FIELD SAFETY NOTICE / PRODUCT NOTIFICATION

Subject: Brainlab Radiation Treatment Planning Software:
 For use in the Brainlab software, image sets other than CT must only contain the same pixel values calibration for all images/slices of the set.

Product Reference: iPlan RT Image (below v.4.1.2) / iPlan RT; and BrainSCAN (discontinued).

Brainlab Identifier: **CAPA-20150727-001458**

Figure 2 Sagittal reconstructions of axial PET images (without SUV) illustrating the possible effect: Left - display of supported set with uniform calibration. Right - display of unsupported set containing varying calibrations.

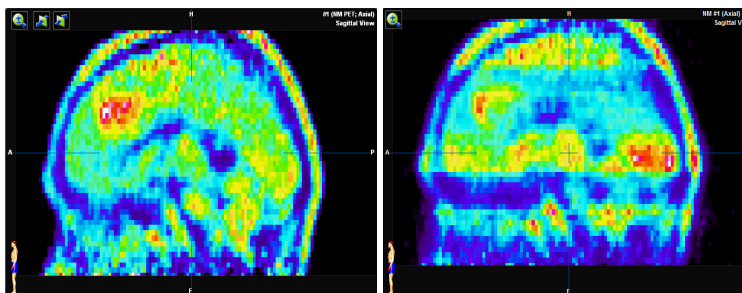
If this effect occurs when using an unsupported image set, it can be misleading to the user during treatment planning and, for example, result in an incorrect definition of volumes of interest in the planning software. The objects created for these volumes of interest might differ in location or dimension from the actual desired definition of the structure. If not detected by the user during treatment planning, as a consequence target volumes could be erroneously defined for an irradiation plan. This could ultimately result in **ineffective treatment, serious patient injury or even death of the patient.**

Figure 2 below illustrates how this effect could influence the appearance of e.g. a sagittal reconstruction of an unsupported axial PET image set. The areas of the highest and lowest activity might seem to be located in a different region of the reconstruction.

- Except for CT and PET used with SUV, only load and use image sets in iPlan RT / iPlan RT Image that have the same pixel value calibration for all images of the set.
- Before using image datasets loaded into the Brainlab Radiation Treatment Planning Software, always compare the images displayed in the Brainlab application to the images as displayed by the imaging device (scanner), e.g. using a different display media approved and available to the hospital other than the Brainlab software. Delete and do not use the image sets within iPlan RT in case any deviation is detected and contact Brainlab support.

Figure 3 Example of axial PET images (without SUV) illustrating the possible effect:

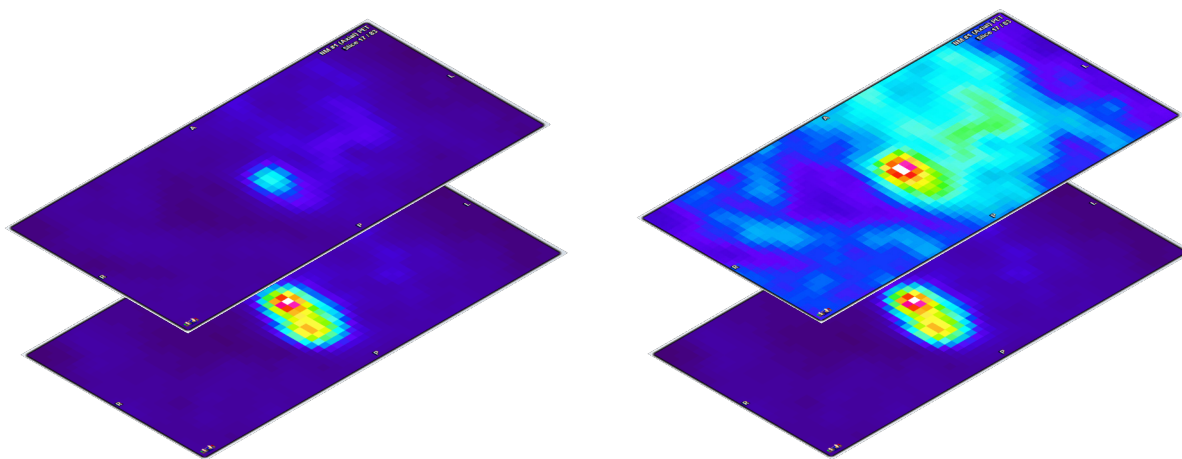
Usually the same calibration is applied to all images of one image set, but in some cases this might be set up differently at the imaging device. If *Rescale Slope/Intercept* differs in between slices of one set, the image set is not supported by the Brainlab planning software except for CT and PET used with SUV. When using such an unsupported image set with the Brainlab software, areas in different slices that would have the same physical or anatomical properties when displayed by the scanner using varying calibrations, might have different values in the Brainlab software due to the uniform calibration to all slices (refer to Figure 3).

Left - display of supported slices (uniform calibration). Right - display of unsupported upper slice (varying calibration).

Note: In such an unsupported PET, in the reconstruction (see Figure 2) the area of the highest activity might appear to be located in different regions (other slices of the set) - in comparison to the display by the scanner using varying calibrations - whereas within each single image slice the areas of the highest and lowest activities still remain at the same place.
